Item ID: D212-664-201

Item Name: Aft Crosstube - High

Sequence ID/ Work Center ID	Operation Description	Set Up/ Run Hours	Tool ID	Tool #	Plan Code	Accept Qty	Reject Qty	Reject Number	Insp. Stamp
Draw Nbr	Revision Nbr								
D212-664-241	Rev D (DEO)								
DSI9563	B

DRAWING NO. D212-664-241	TITLE CROSSTUBE ASSY (205/212 HI AFT)	REV. D	DART AEROSPACE LTD ENGINEERING ORDER		D.E.O. NO. D212-664-241-D-1	SHEET NO. SHEET 1 OF 2	SCALE NTS
DRAWN	CHECKED	MFG. APPR.	APPROVED	DE APPR.			
DATE 11.04.07	DATE 11.04.11	DATE 11.04.12	DATE 11/04/12	DATE 11.04.12

**FIGURE 1: SUPPORT INSTALLATION**

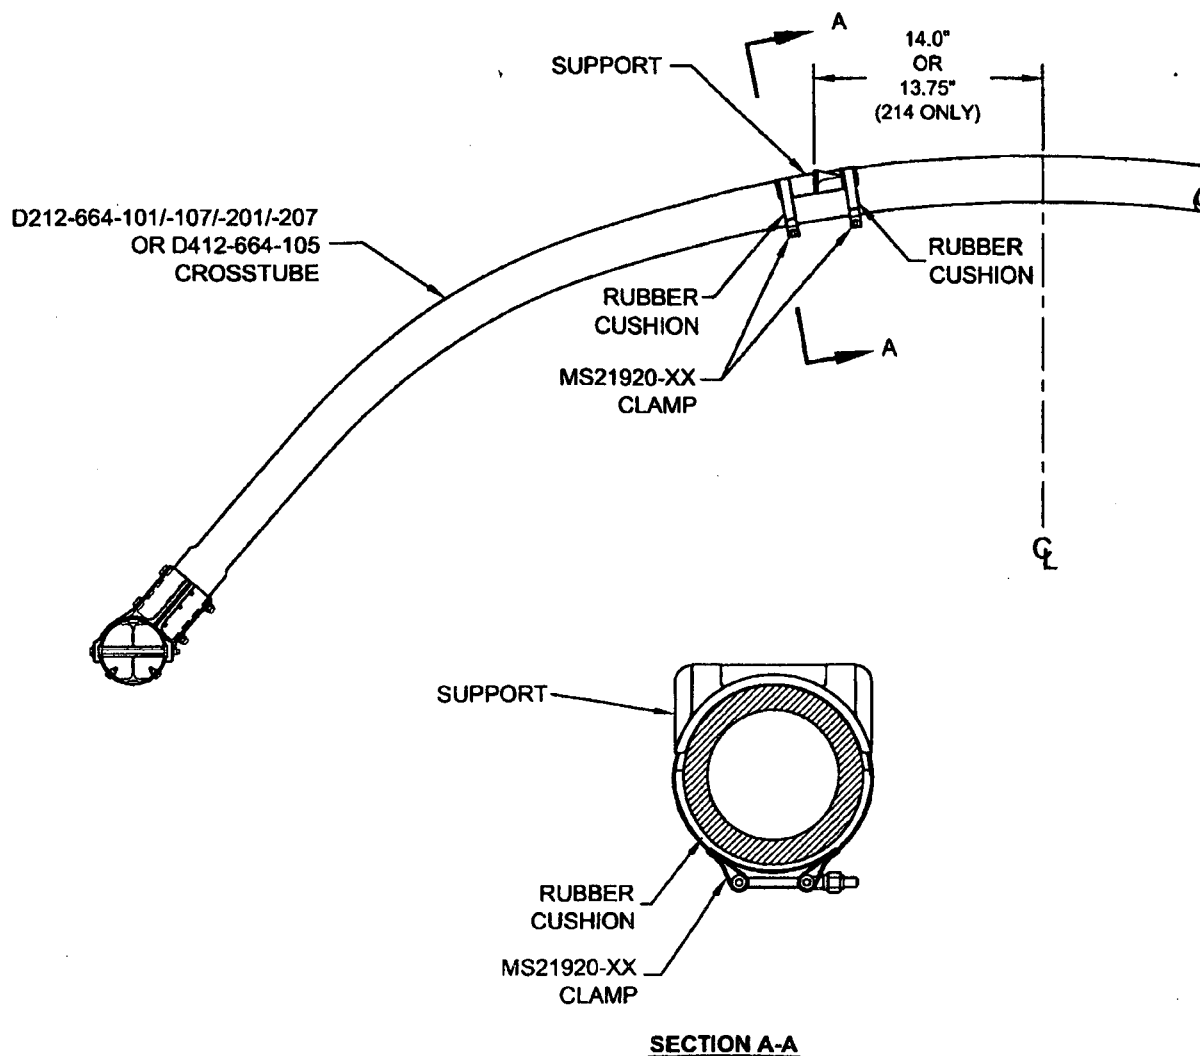
For the crosstubes listed above, section 32.4 of ICA-D212-664 is amended as follows. Use Figure 1 of this service instruction and Figures 32-2 to 32-9 of ICA-D212-664 for further reference. For crosstubes of an earlier change number, it is recommended that if the supports are removed, the supports should be reinstalled using the procedure listed below.

- 32.4.1 Locate the area on the crosstube for installation of support (see Figure 1 of this service instruction). For D212-664-101/-107/-201/-207 and D412-664-105 crosstubes, the outward face of the support tabs should be 14.0" (355mm) from the crosstube center for 204/205/210/412/UH-1 aircraft. For installation on 214B/B-1 aircraft, the outward face of the support tabs should be 13.75" (349mm). Ensure paint finish of crosstube is intact; touch up as required per Chapter 5 (5.3.9) of ICA-D212-664.

- 32.4.2 If present, remove any paint/primer on bottom of supports. Abrade mating surfaces of support and crosstube with 400-grit sandpaper. Saturate a clean cloth with MEK or 4105S Wash'n'Wipe Degreaser or equivalent and wipe until there is no residue.

- 32.4.5 Apply a 0.04" to 0.07" thick layer of Proseal 890 Class B or AMS-S-8802 Class B sealant underneath applicable support and install support as shown in Figure 1 of this service instruction.

- 32.4.6 Install the clamps opposite to crosstube support as shown in section A-A of Figure 1. Install rubber cushions underneath each clamp around the bottom circumference of the crosstube up to the crosstube centerline. Torque clamps 80-100 in-lb (9.0-11.3 Nm). It is acceptable to use smaller or larger sized MS21920-XX clamps than those listed in ICA-D212-664, ensure that after torquing the clamps per this instruction, the nuts are in safety but not bottomed out

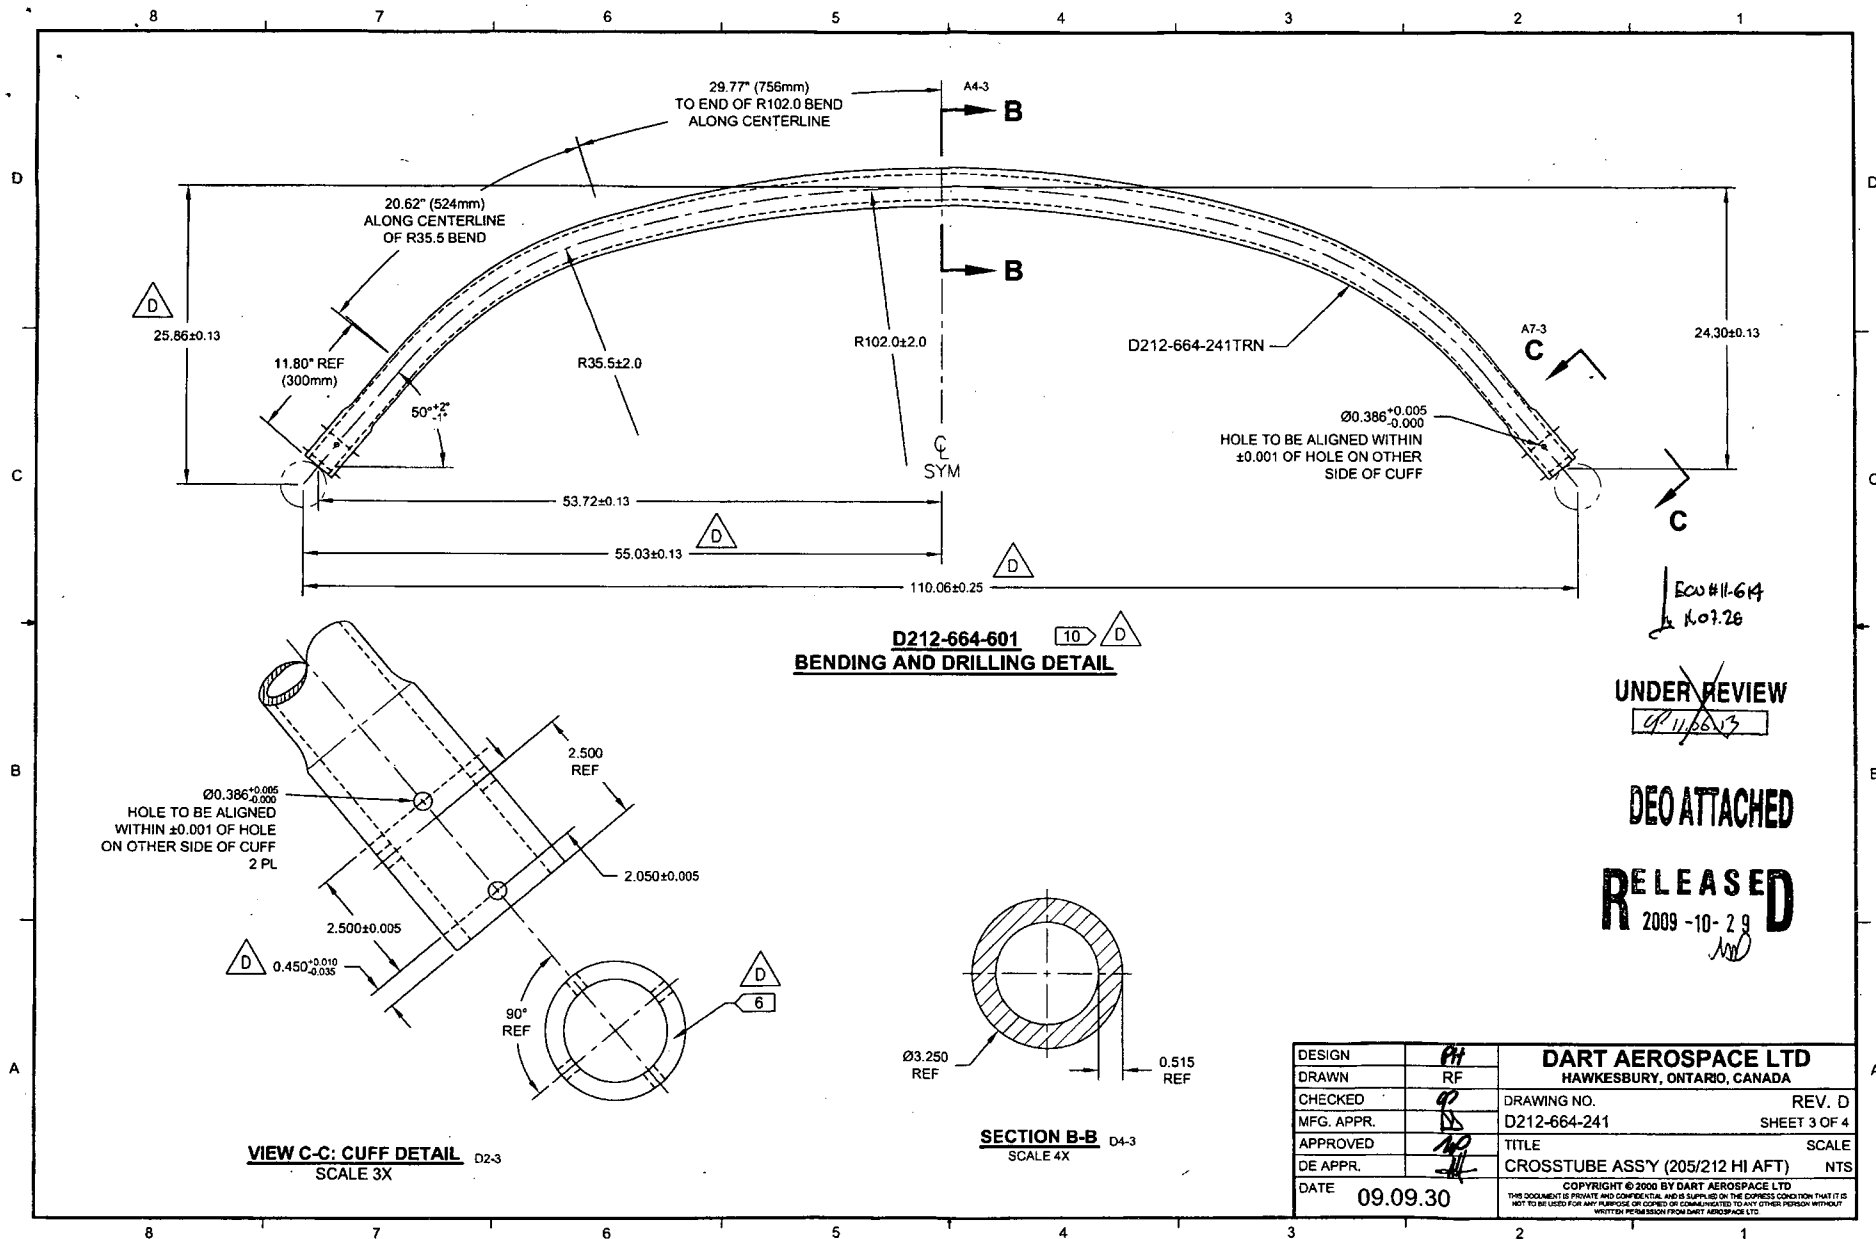
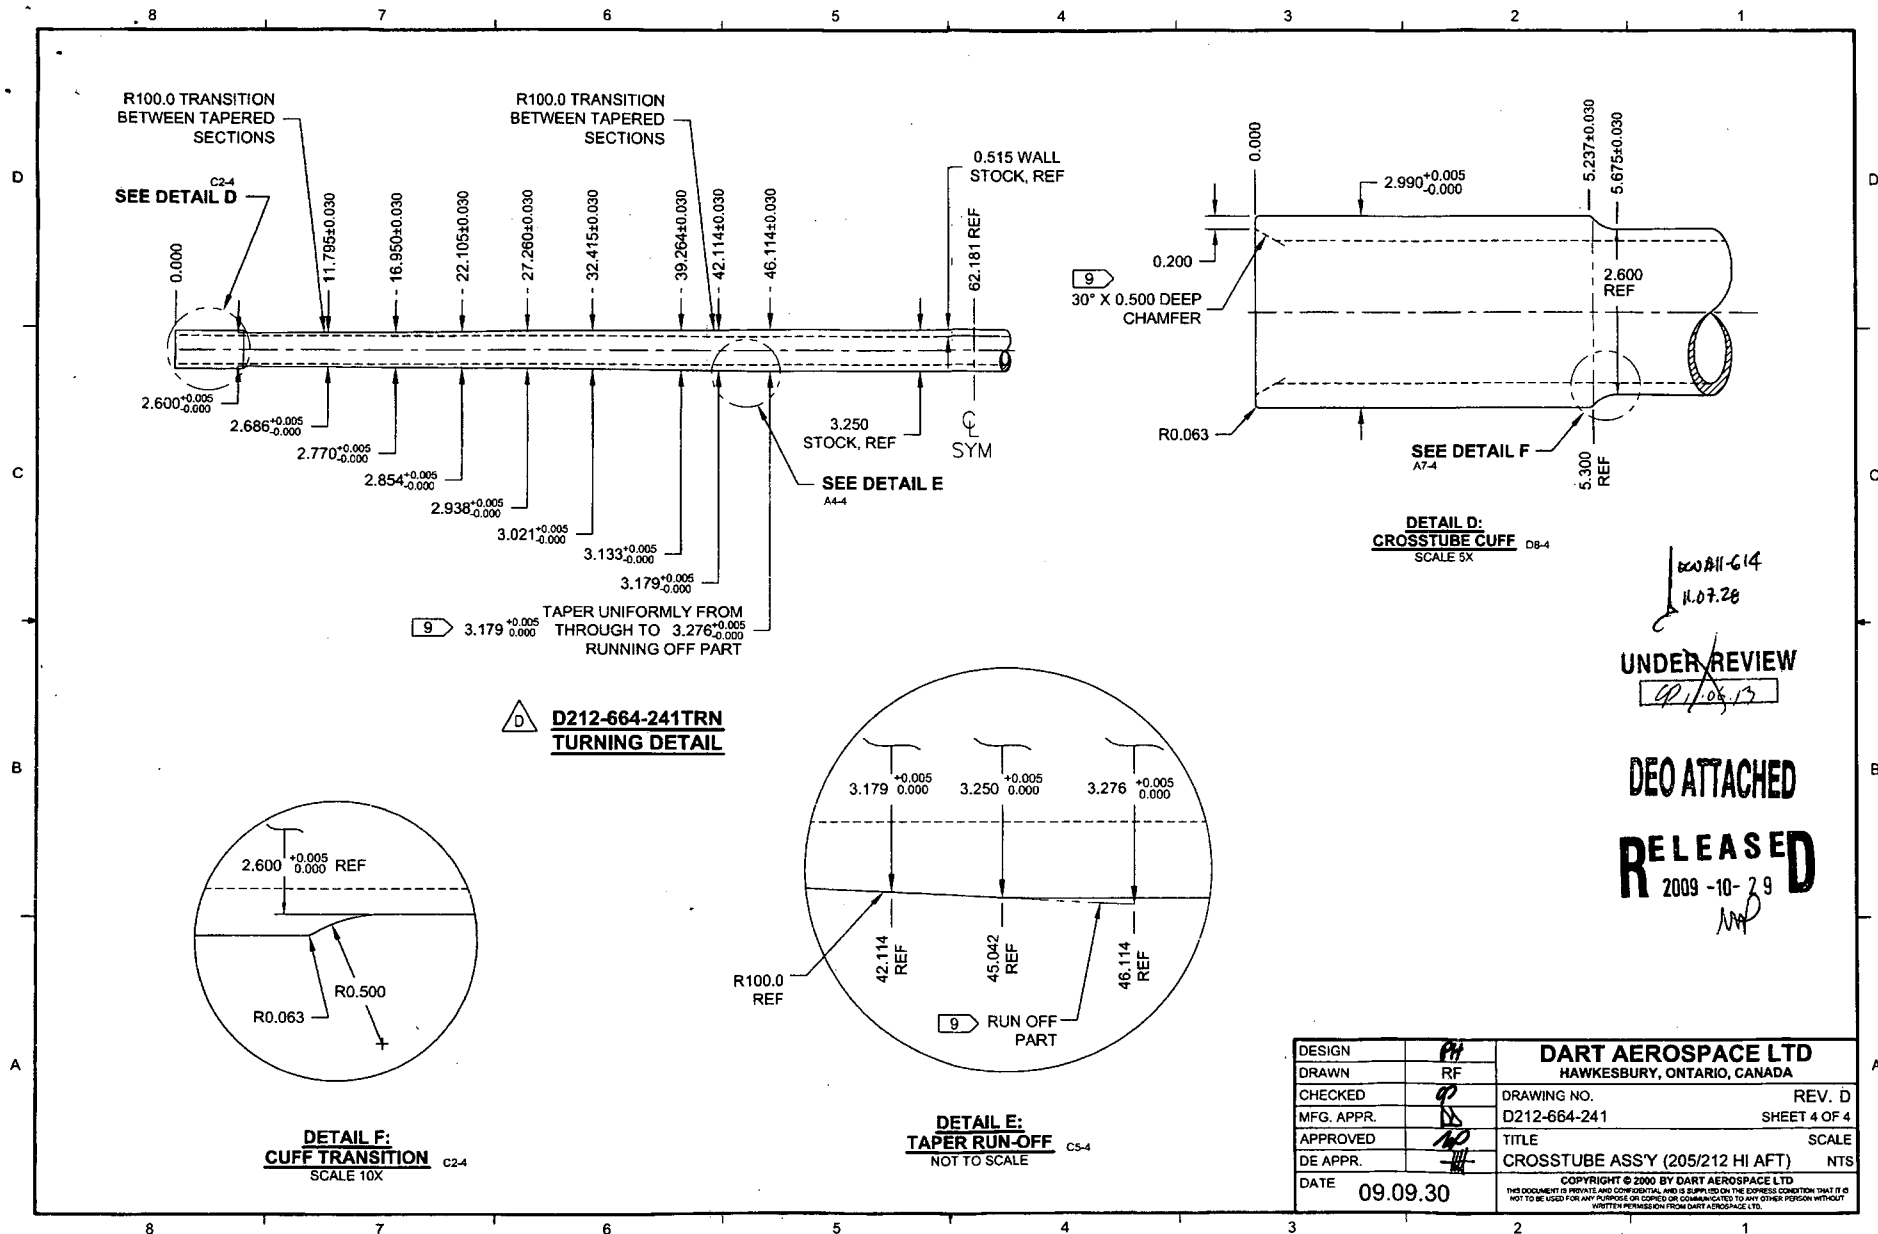
REPLACE MAGNOBOND WITH PROSEAL.

NOTE 12 & 15, SHEET 1 IS AMENDED AS FOLLOWS:

- 12) TO INSTALL D2940-1 SUPPORT: ABRASE MATING SURFACE OF SUPPORT AND CROSSTUBE WITH 180-GRIT SANDPAPER AND REMOVE RESIDUE WITH MEK (OR EQUIVALENT). APPLY A 0.04" TO 0.07" THICK LAYER OF PROSEAL 890 CLASS B-2 (OR AMS-S-8802 CLASS B-2) SEALANT TO MATING SURFACE OF SUPPORT.
- 15) TORQUE CLAMPS 80 TO 100 IN-LB. ENSURE AT LEAST 1.5 THREADS SHOWING IN SAFETY AND THAT NUT HAS NOT BOTTOMED-OUT AFTER TORQUING. **PRIOR TO PACKAGING, RE-CHECK TORQUE ON CLAMPS AFTER PROSEAL 890 SEALANT HAS CURED FOR 72 HOURS.**

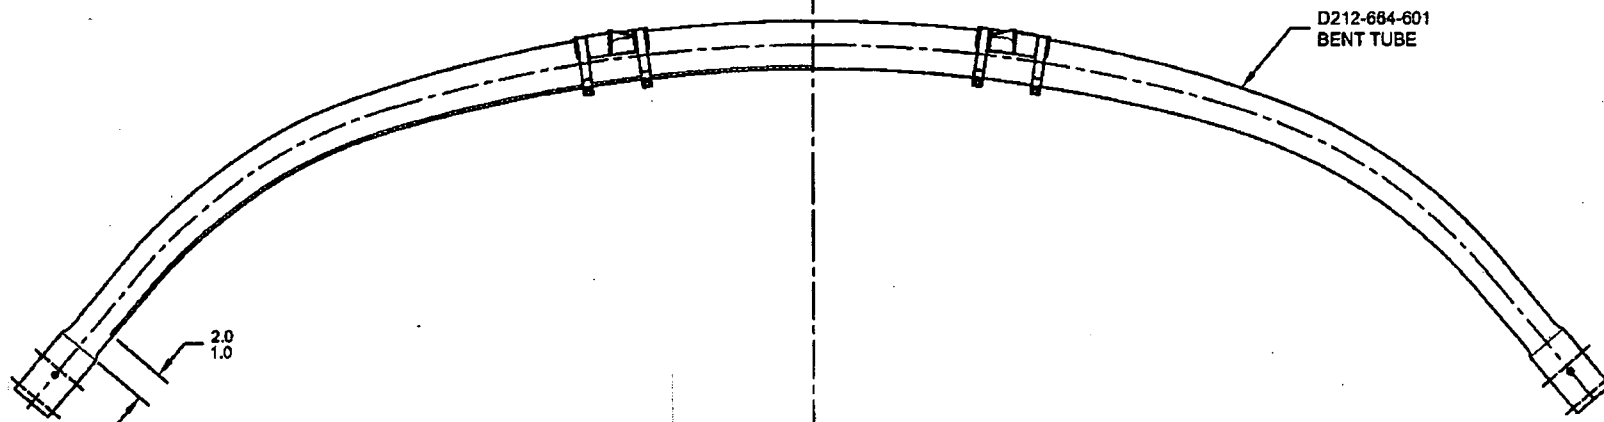
**PURPOSE:**

ADD AN INSPECTION WINDOW TO UNDERSIDE OF CROSSTUBE.

NOTES 2 OF SHEET 1 IS AMENDED AS FOLLOWS:

- 2) FINISH: CHEMICAL CONVERSION COAT PER DART QSI 005 4.1  
PRIME INSIDE AND OUTSIDE PER DART QSI 005 4.2  
MASK UNDERSIDE OF CROSSTUBE AS SHOWN (HATCHED AREA) AND  
PAINT OUTSIDE PER DART QSI 005 4.2  
REMOVE MASKING AND APPLY CLEAR COAT
